COOLING Caravan 3110

SERVICE BULLETIN

RM 8400/01/05, 8500/01/05/50/51/55, RML 8550/51/55, RMS 8400/01/05/60/61/65, RMS 8500/01/05/50/51/55

Door lock with lighting

Door lock with lighting, left hang, spare part number 241 3267-41/6

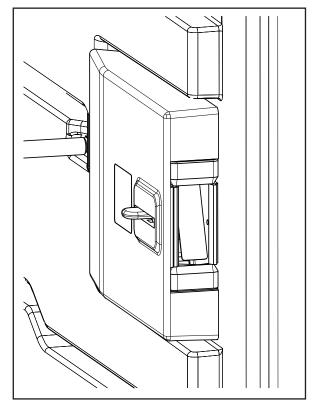
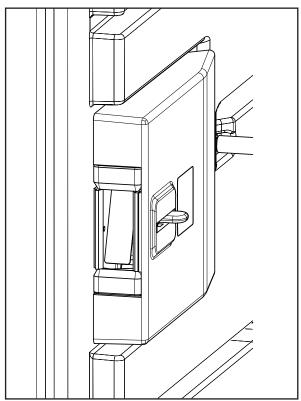
The door lock with lighting 241 3267-01/0 is no longer available. Instead of this door lock depending on the door hang one of the following door locks have to be used:

At fridges, which control the lighting with a sensor (295 1380-11/8 or 295 1380-51/4) inside of the control panel, the sensor must not be removed.

241 3267-41/6, Door lock with lighting, left hang 241 3267-51/5, Door lock with lighting, right hang
